**ADDENDUM
NO. 01**

June 14, 2024

**Additions and Renovations to Franklin Central High School Phase 2B
6215 S. Franklin Rd.
Indianapolis, IN, 46259**

Figure 3.2-A

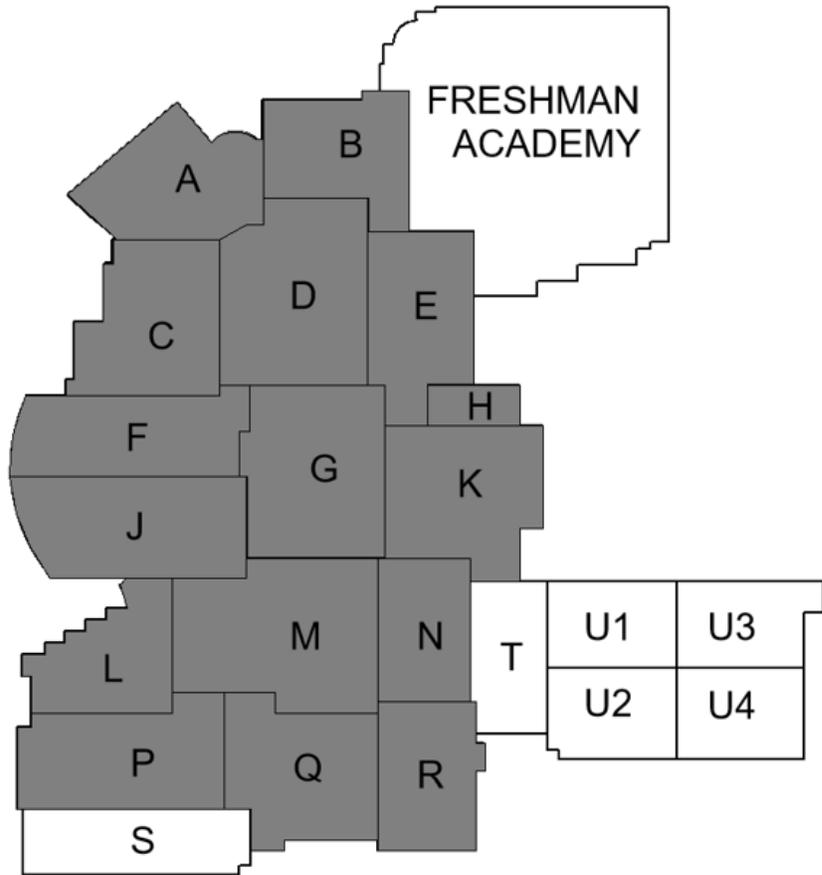
- B. See Figure 3.2-A for new piping drain installation base bid scope of work. The Mechanical Contractor and Water Treatment Contractor shall be responsible for field investigation and shall find the low points of chilled water supply and return piping within each building unit indicated in Figure 3.2-A. Base bid work shall include installation of piping drains as indicated in Figure 3.2-A. A unit price for additional drains shall be provided. See front end documents and bid form.

- C. Drains shall be hot tapped to limit disruption of the system until draining occurs.
- D. The contractor shall record all new drain connections on an as-built drawing for record.

ADD1-SK1

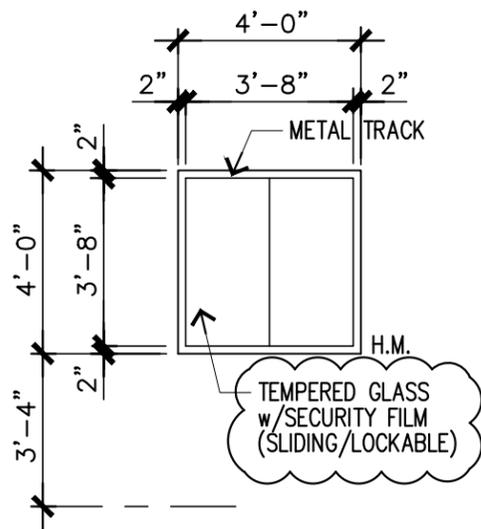
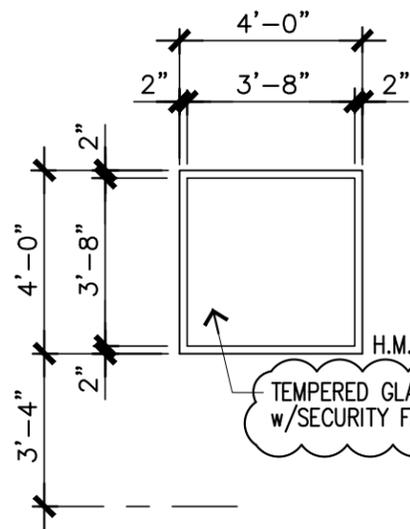
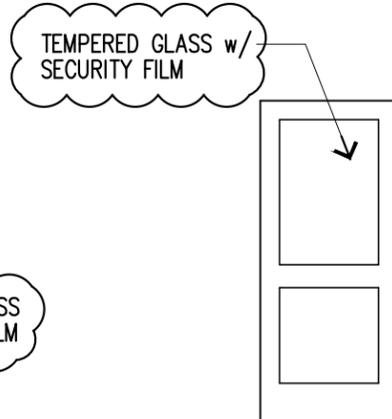
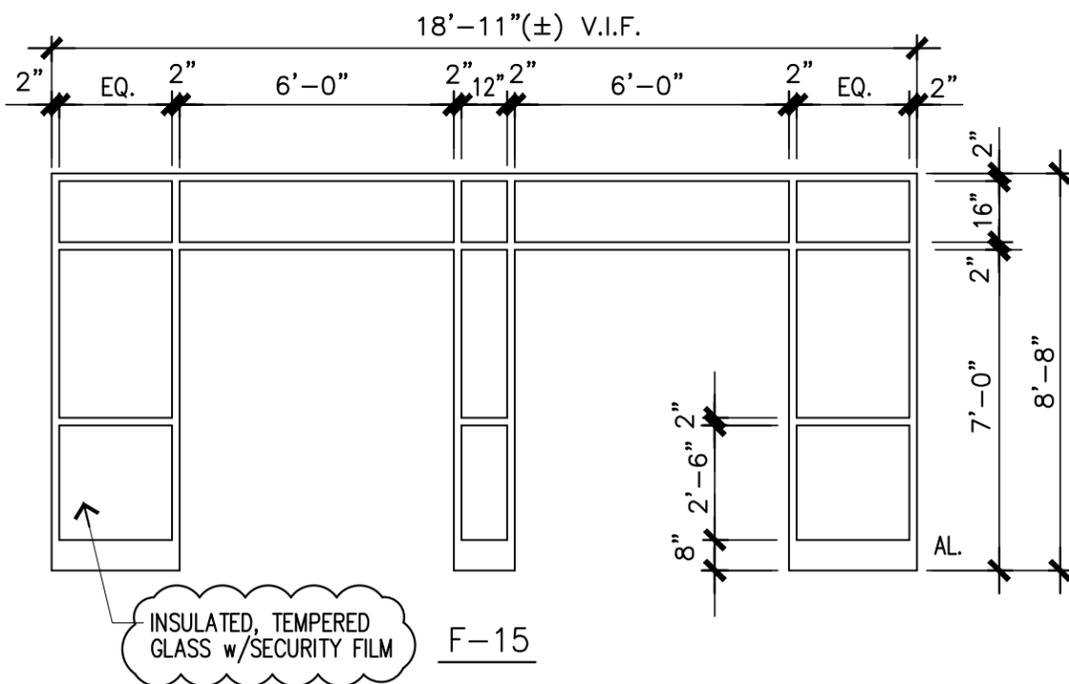
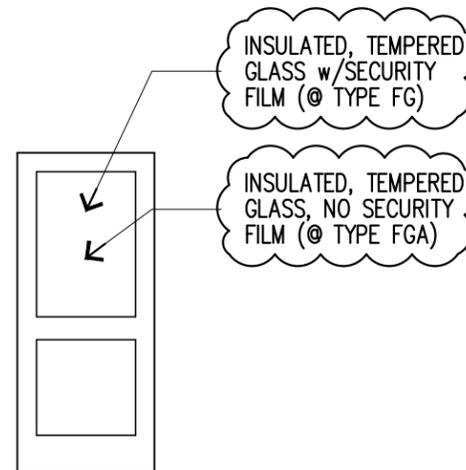
- 1-43 S202: The stair at the end of Corridor T110 (Detail reference 3/S302) shall be constructed per Detail 17/C252.
- 1-44 Sinks shall be added in countertops in Dressing Rooms F122 and F123 as indicated on attached sketch, ADD1-SK1.

ADD1-SK2

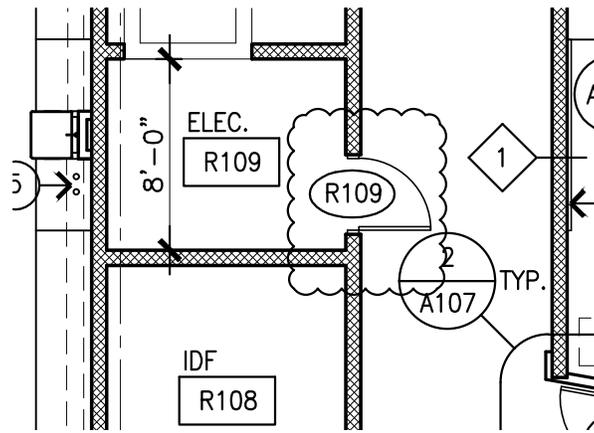
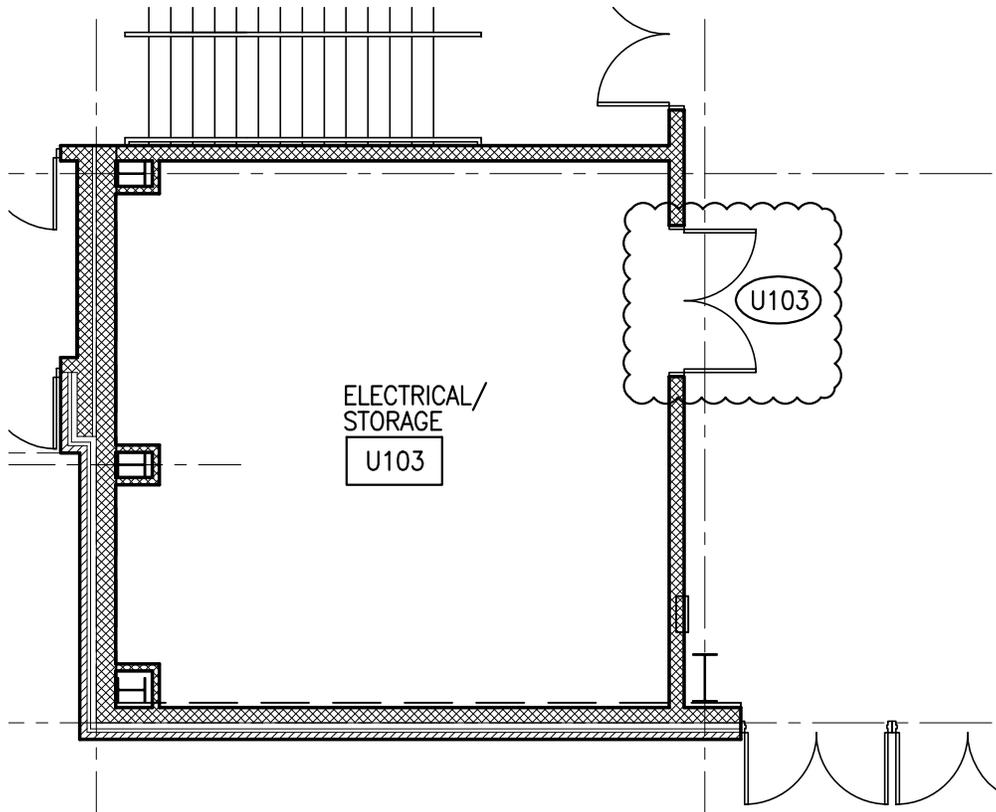
- 1-45 Revise door and window glazing, including the application of security film where noted, as indicated on attached sketch, ADD1-SK2.
- 1-46 At Electrical Room R109 and Electrical/Storage Room U103, door swings of doors R109 and U103 shall be reversed, as indicated on attached sketch, ADD1-SK4.

ADD1-SK4

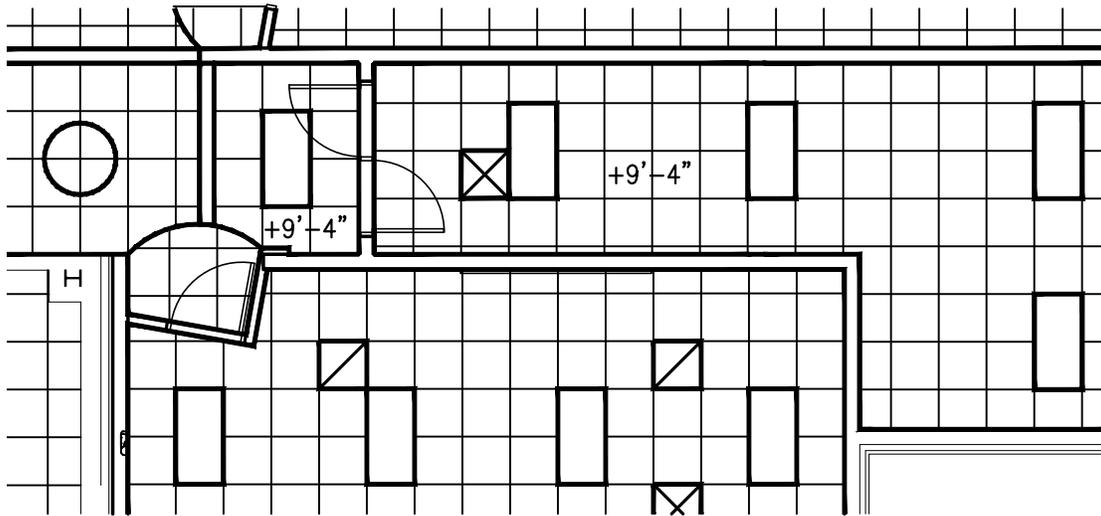
- 1-39 A102:
 - A. Add nom. 8" CMU wall between sets of doors, as indicated on attached sketches, ADD1-SK3 and ADD1-SK4.
 - B. Delete reference to doors J150 and J150A (these are identified as M107 and M107A on drawing A104).

1 PARTIAL FIRST FLOOR REFLECTED CEILING PLAN - UNIT T
 A108 SCALE: 1/8" = 1'-0"

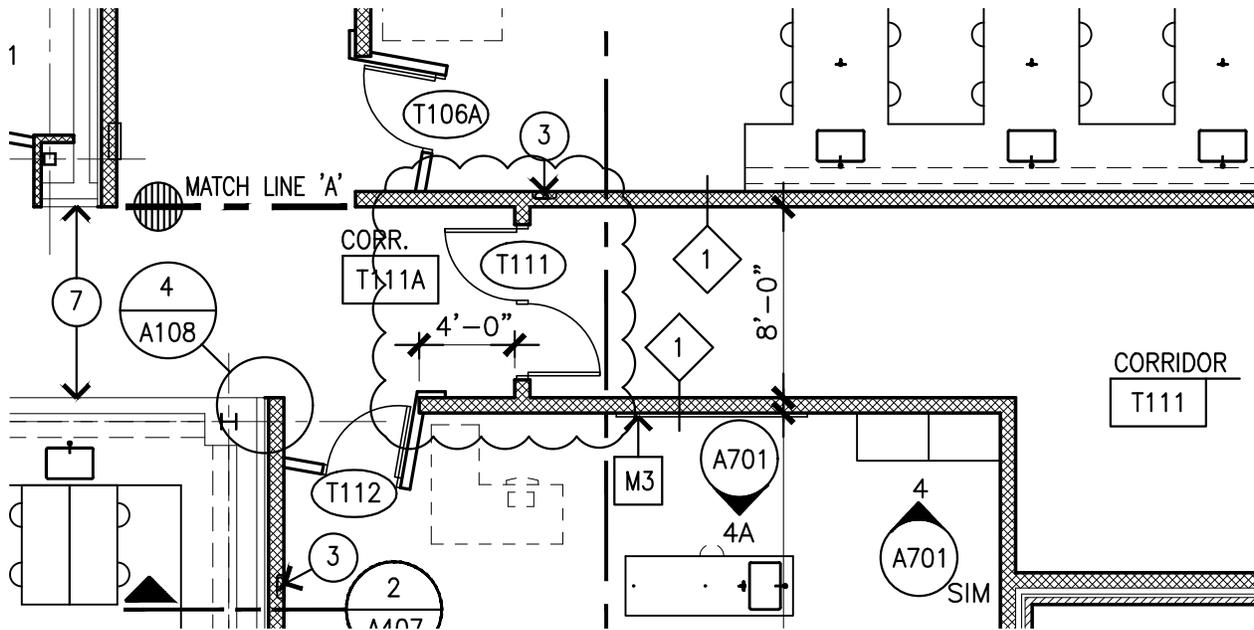
- 1-47 Doors T111 shall be relocated to the West as indicated on attached sketch, ADD1-SK5.
- 1-48 Reflected Ceiling Plan at Corridors T111 and T111A shall be revised as indicated on attached sketch, ADD1-SK5.
